# 2016 Corvette: Service Bulletin: Delayed Engagement After Sitting With Engine Off

## #16-NA-014: Delayed Engagement After Sitting With Engine Off - (Jan 21, 2016)

**Subject:** Delayed Engagement After Sitting With Engine Off

- (A) Old stator support asm 242  
74636/24275106/2427265  
6
- (B) New stator support asm  
24277234

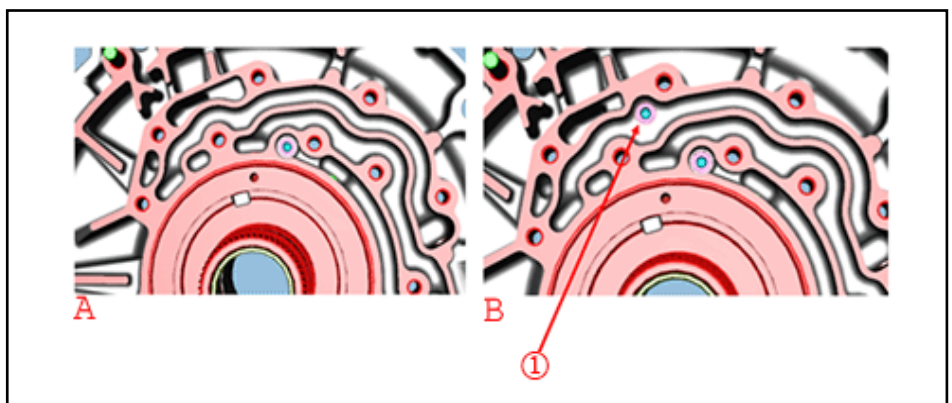
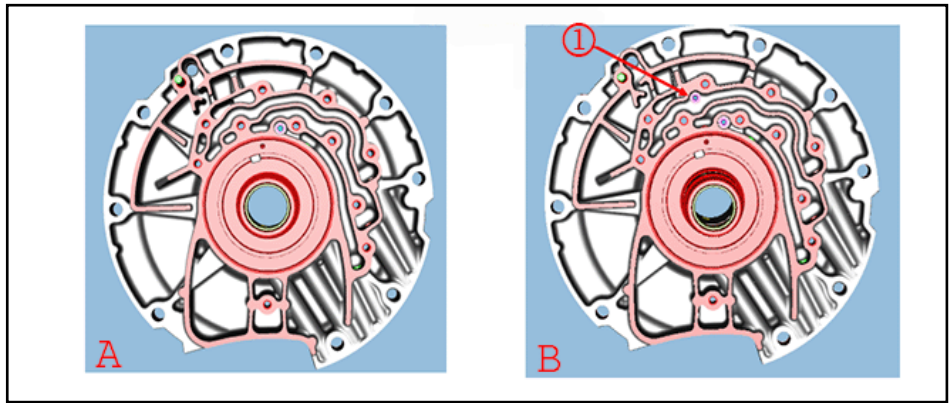
**Note:** The new stator shaft support assembly has a second check ball (1) added (see illustrations).

Install a new stator shaft support assembly that includes an additional check ball. Follow the instructions below to replace the stator shaft support assembly.

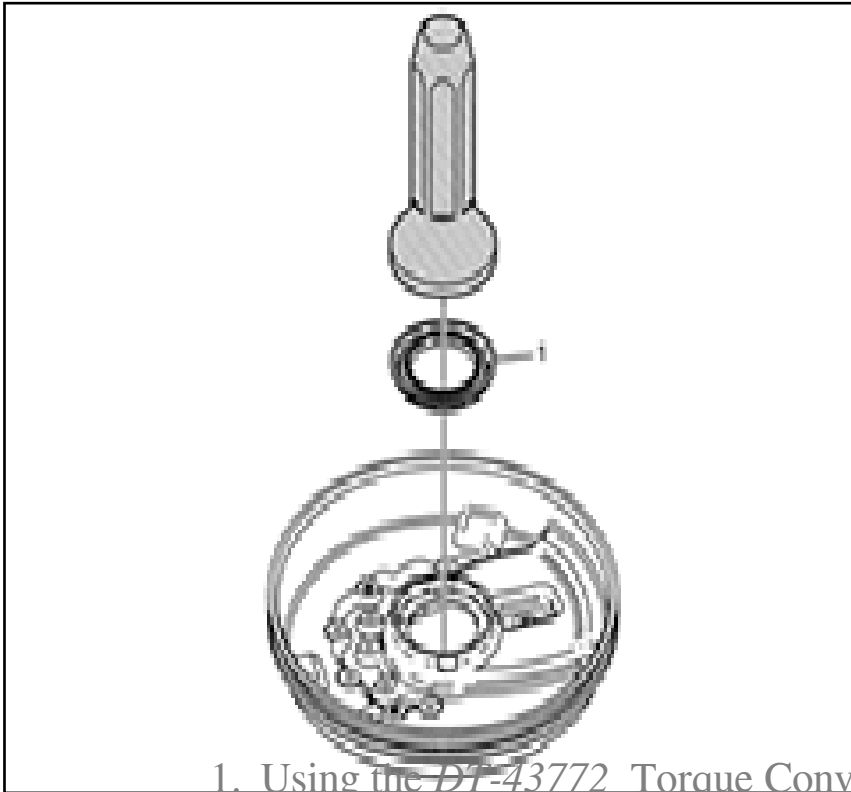
**Note:** The casting void has been eliminated from the underside of the cover (see illustration).
